## ADDENDUM No. 1

### ITB No. 4669 - 2021 MISCELLANEOUS UTILITIES PROJECT

W LIBERTY ST TRAFFIC CONTROL - PH I

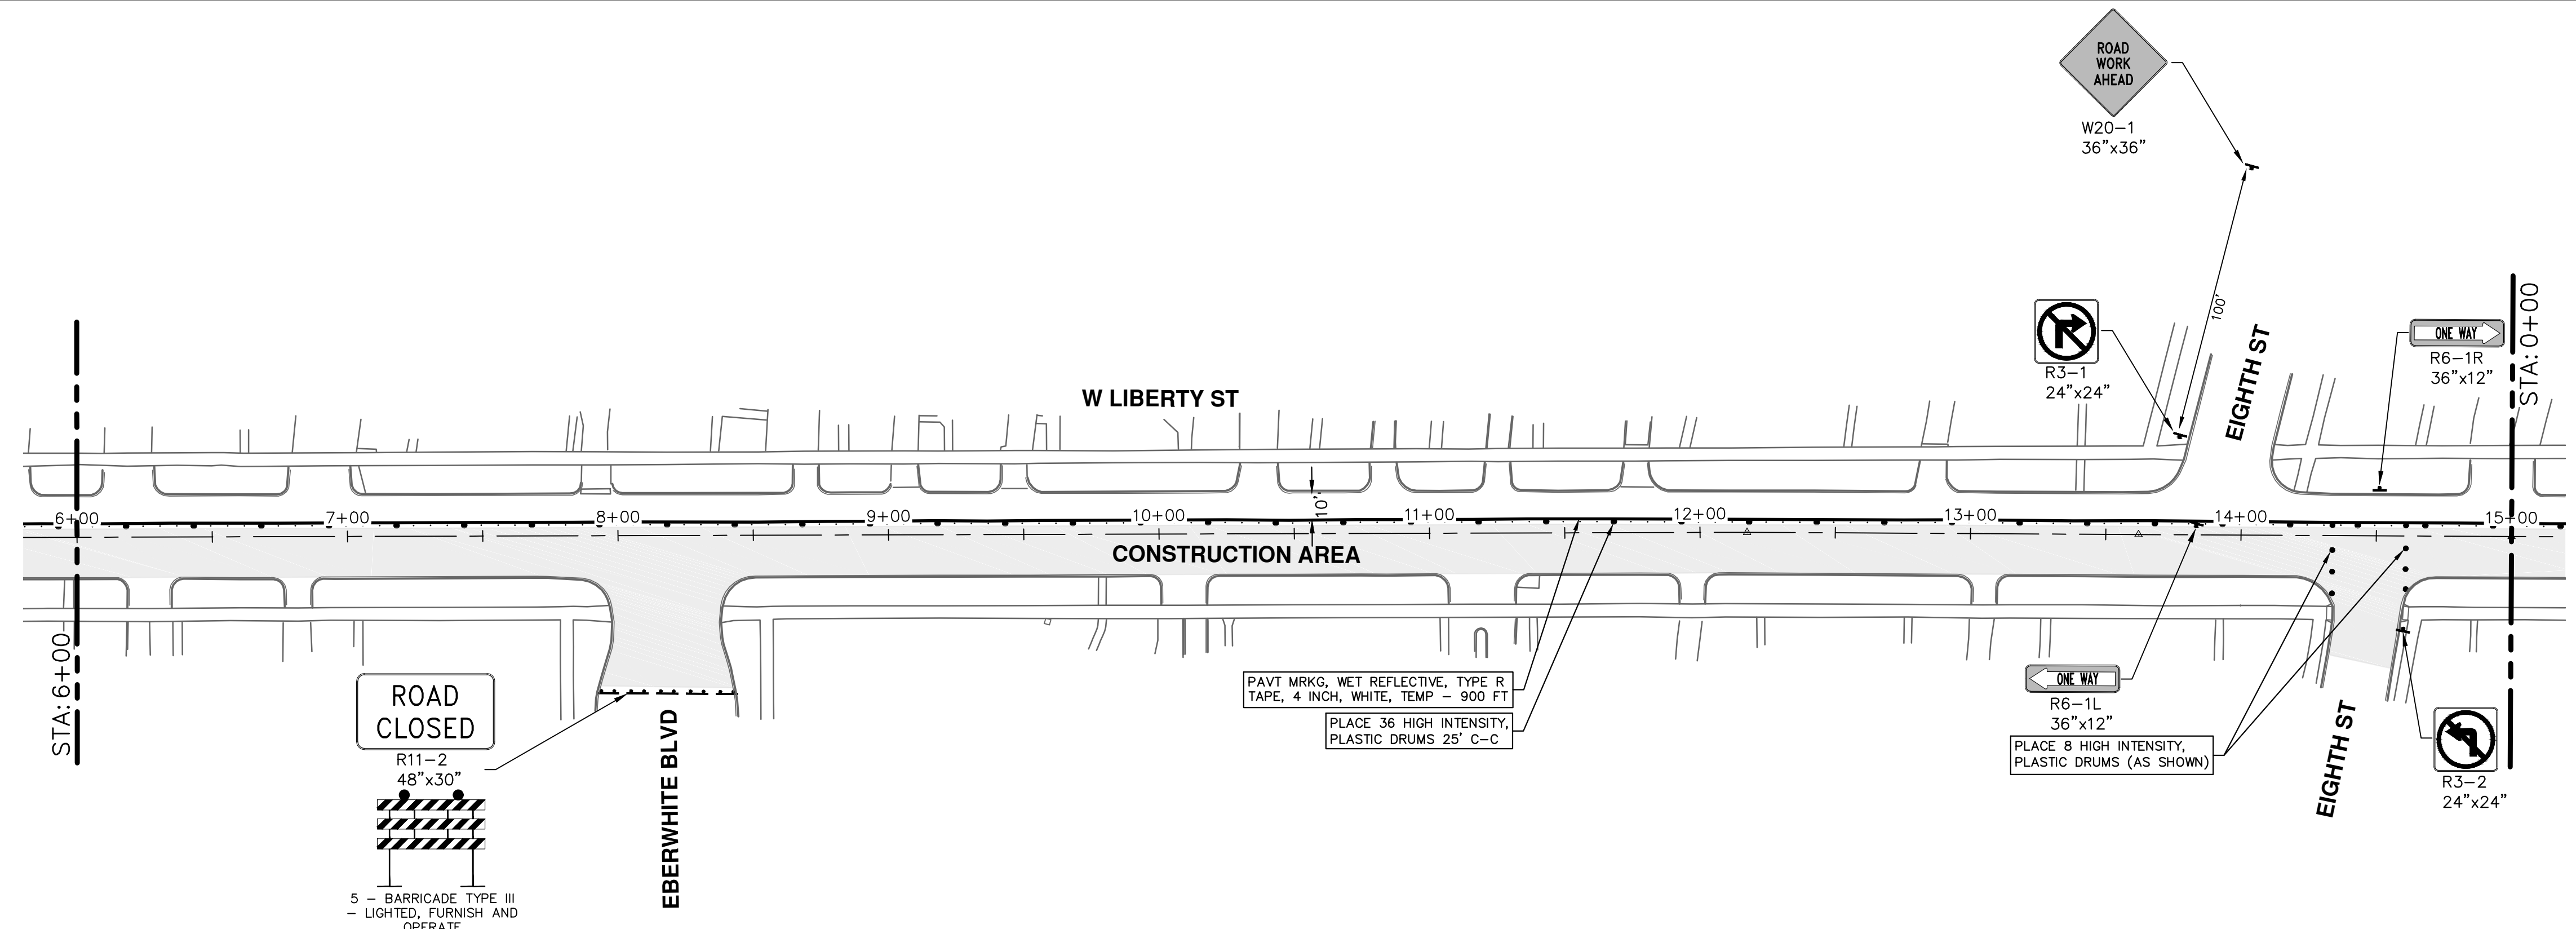
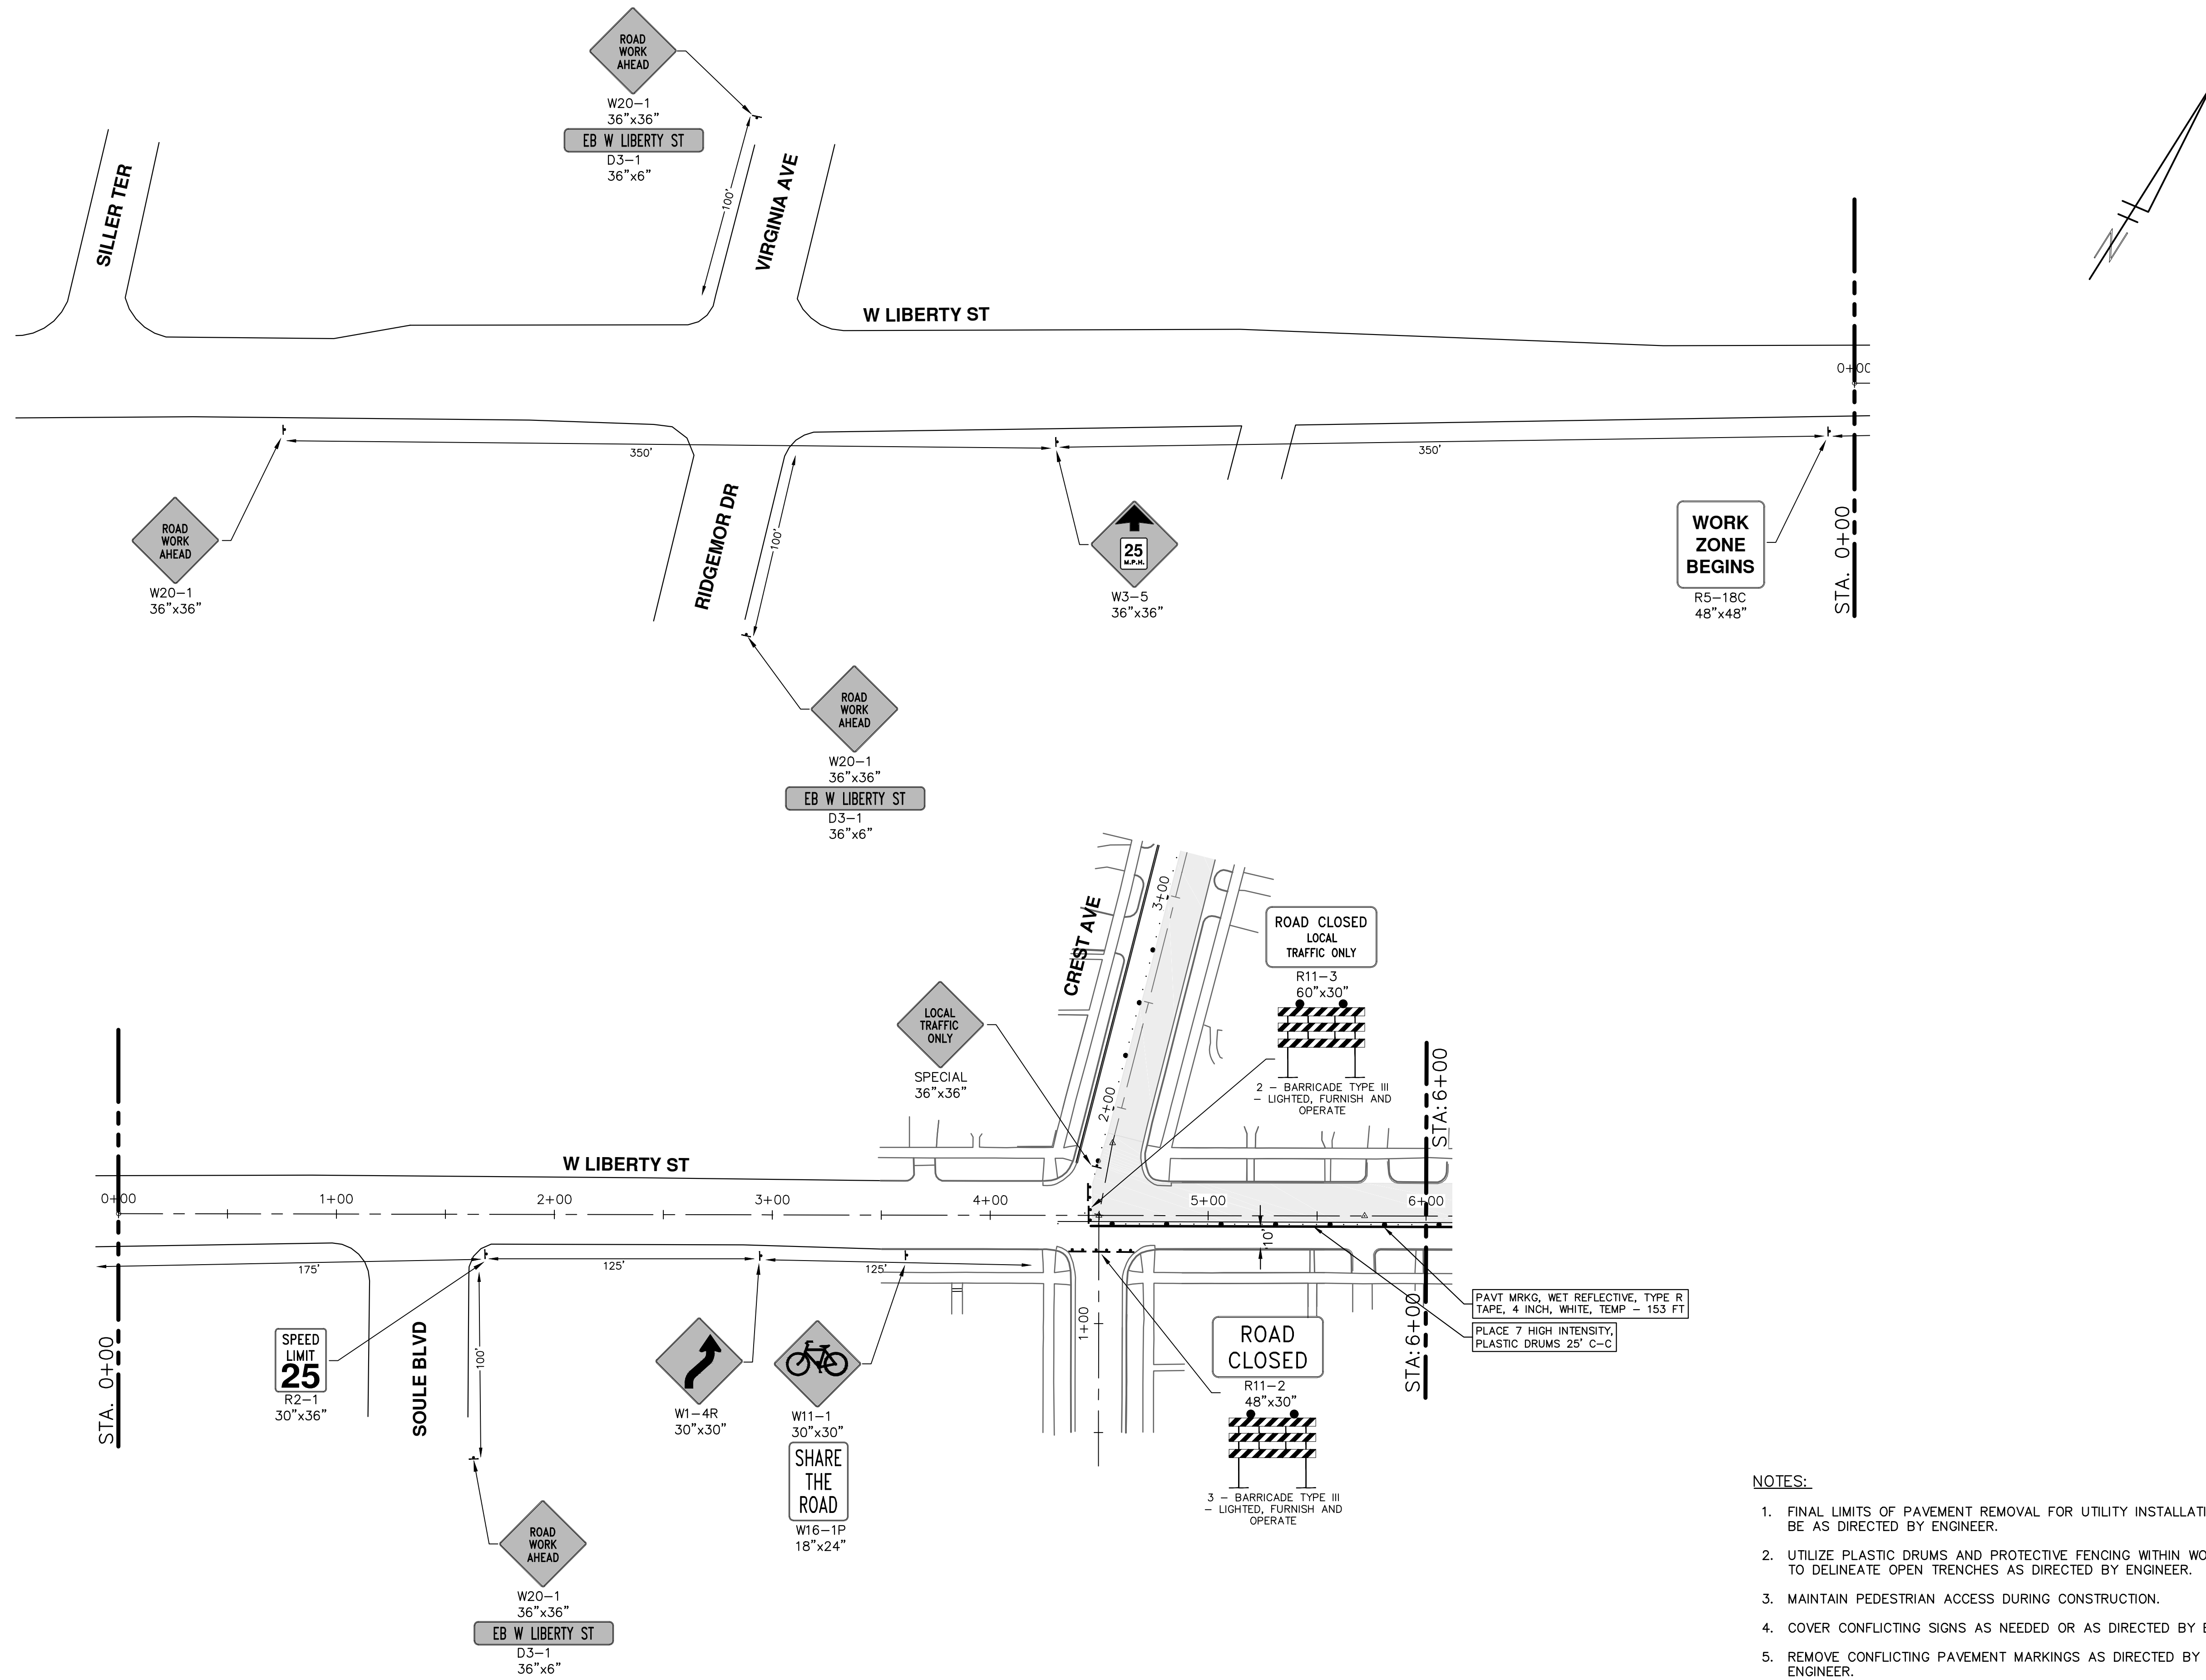
Answer 13: The proposed duration has been revised.
- Question 14: I do not see a MOT plan for the north side (westbound) West Liberty Street construction. I assume that the provided MOT plan will be flip flopped to maintain eastbound traffic when this work is taking place, correct?  
Are the long side water services and transverse water main items that cross West Liberty Street to be performed under traffic, or built part width to the construction limits during a "phase"? Please advise.

Answer 14: West Liberty Street MOT plans have been added for maintaining eastbound traffic on the south side of West Liberty Street.
